Project Title:
Philipse Manor Hall State Historic Site
Construction of Elevator/Restroom
Addition, Interior and
Exterior Rehabilitation and Site
Enhancements

Rev No	Description	Date
1	Addendum #2	6/24/21

Sheet Title:
MANOR TYPICAL EXISTING CONDITIONS

Drawing Number:
A110

1 ROOF BALLUSTRADE WORK
1/16" = 1'-0"

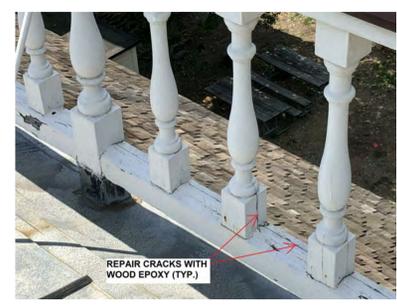
1. REPLACE BOTTOM RAIL, UP TO THREE (3) SECTIONS, 6' TO 8' LONG
2. FILL CRACKS IN BOTTOM RAIL WITH EPOXY, UP TO SIX (6) LOCATIONS
3. FILL CRACKS IN BASE OF TURNED BALUSTERS, UP TO EIGHT (8) LOCATIONS

2 SOUTH PORCH COLUMN REPAIR
1" = 1'-0"

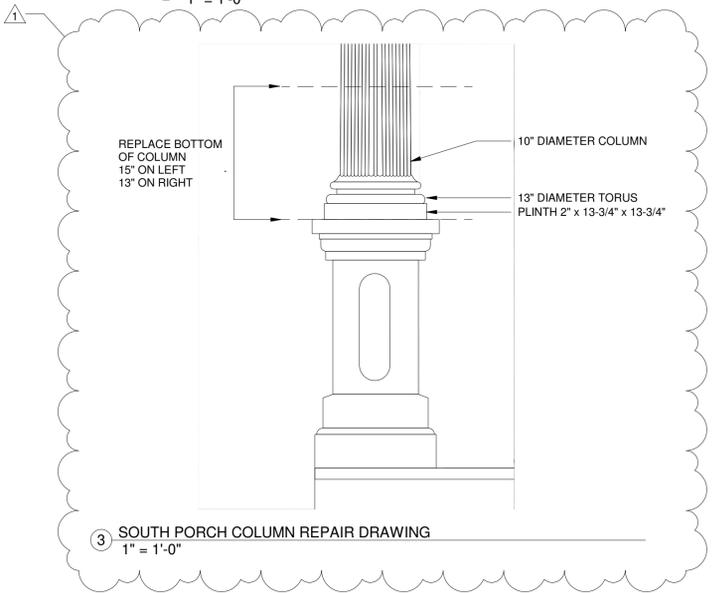
- SOUTH PORCH COLUMN REPAIR**
1. INSTALL TEMPORARY SHORING. REMOVE COLUMNS FOR REPAIR
 2. SEE DRAWING FOR REPLACEMENT OF BOTTOM PORTIONS OF COLUMN SHAFTS AND BASES. REPLICA PORTIONS MUST BE EXACT TO EXISTING DIMENSIONS AND PROFILES.
 3. DISASSEMBLE AND REBUILD LEFT PEDESTAL. REPLACE DETERIORATED BASE MOLDING, CORNER TRIM ON SW CORNER.
 4. REPLACE WEST BENCH, EPOXY REPAIR EAST BENCH.
